3B Containment Hydrodynamic Loads

The information in this appendix of the reference ABWR DCD, including all subsections, tables, and figures, is incorporated by reference with the following departures.

STD DEP 3B-2 (Table 3B-1, Figures 3B-12 and 3B-13)

STD DEP Admin (Figures , 3B-21, 3B-24, 3B-26)

Figure 3B-12 Time History of Air Bubble Pressure

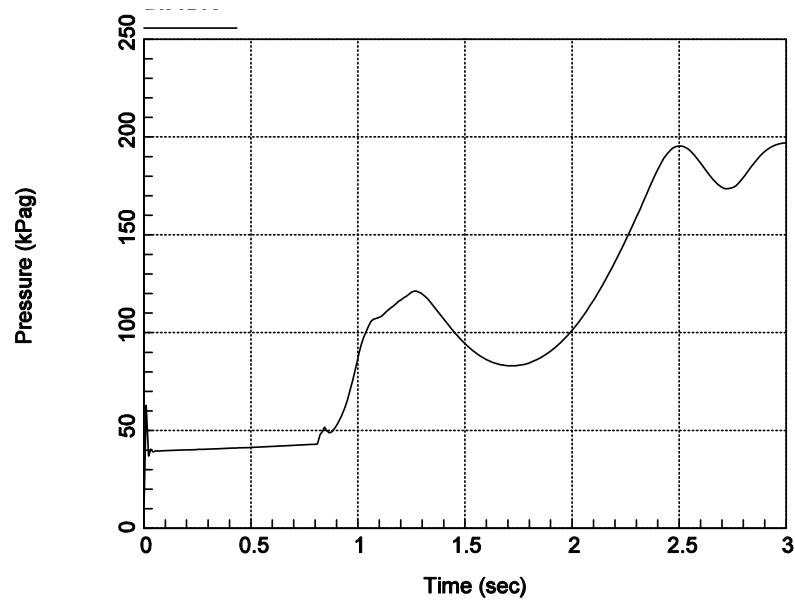
Description	Value
1. Air bubble pressure (maximum)	133.37 kPaG <u>195 kPaG</u>
2. Pool swell velocity (maximum)	<u>10.9 m/s</u>
3. Wetwell airspace pressur (maximum)	107.87 kPaG <u>146 kPaG</u>
4. Pool swell height (maximum)	7m <u>8.8m</u>

Figure 3B-13 Schematic of the Pool Swell Phenomenon

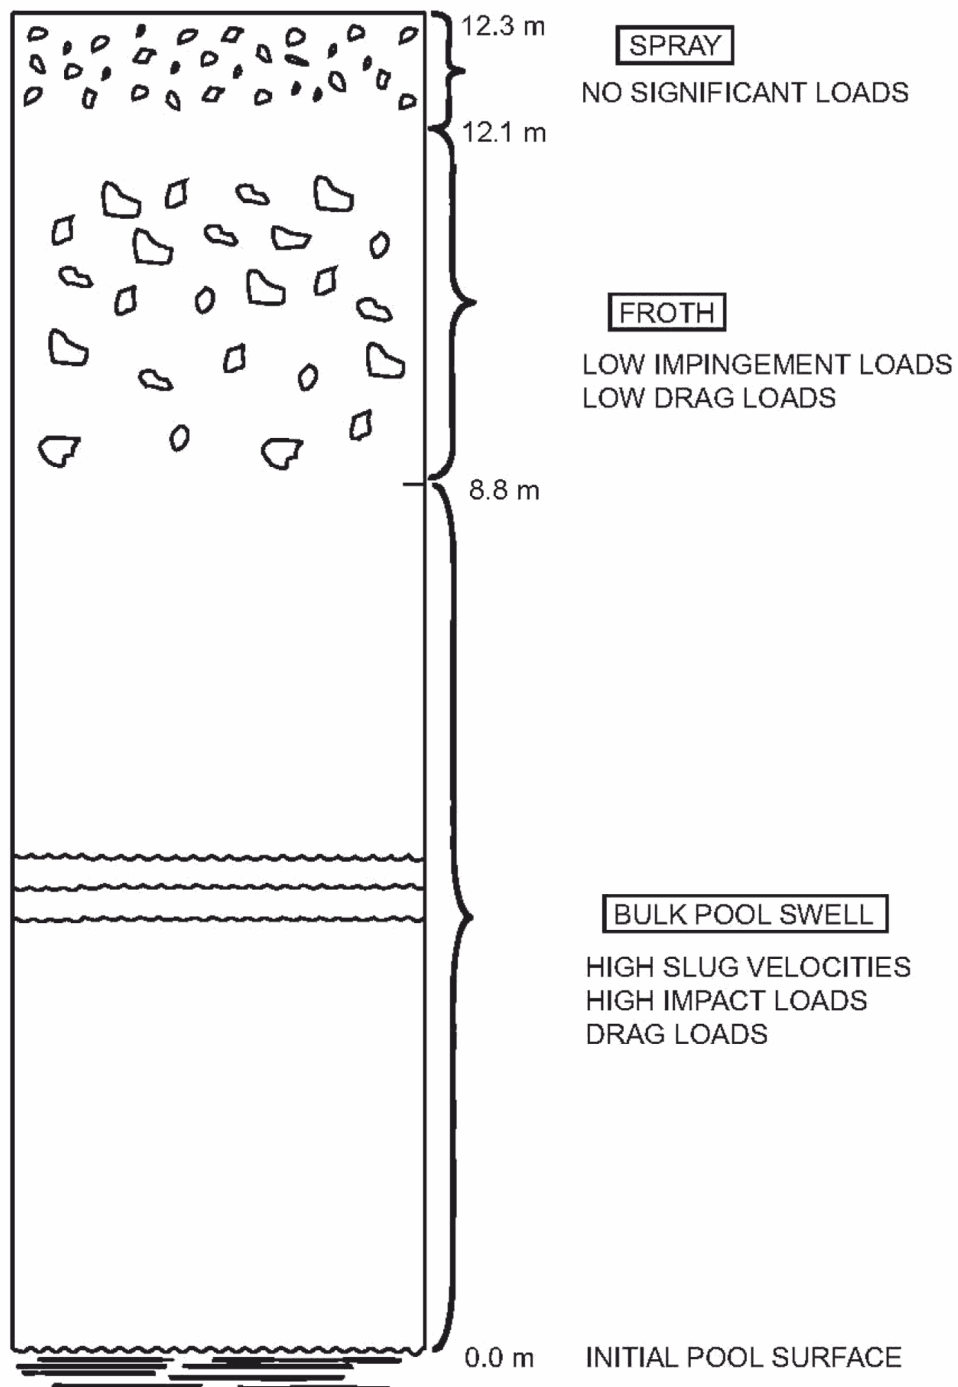
Structures located between 0 and ~~7m~~8.8m above the initial surface will be subjected to impact load by an intact water ligament, where the ~~7m~~8.8m value corresponds to the calculated maximum pool swell height. The load calculation methodology will be based on that approved for Mark II and Mark III containments (NUREG-0487 and NUREG-0978).

Structures located at elevations between the ~~7m~~8.8m and ~~40.3m~~12.1m will be subjected to froth impact loading. This is based on the assumption that bubble breakthrough (i.e., where the air bubbles penetrate the rising pool surface) occurs at ~~7m~~8.8m height, and the resulting froth swells to a height of 3.3m. ~~This froth swell height is the same as that defined for Mark III containment design and this.~~ This is considered to be conservative for the ABWR design. Because of substantially smaller wetwell gas space volume (about 1/5th of the Mark III design), the ABWR containment is expected to experience a froth swell height substantially lower than the Mark III design. The wetwell gas space is compressed by the rising liquid slug during pool swell, and the resulting increase in the wetwell gas space pressure will decelerate the liquid slug before the bubble break-through process begins. The load calculation methodology will be based on that approved for the Mark III containment (NUREG-0978).

As shown in Figure 3B-13 the gas space above the ~~40.3 m~~12.1m elevation will be exposed to spray condition ~~including~~ which is expected to induce no significant loads on structures in that region.
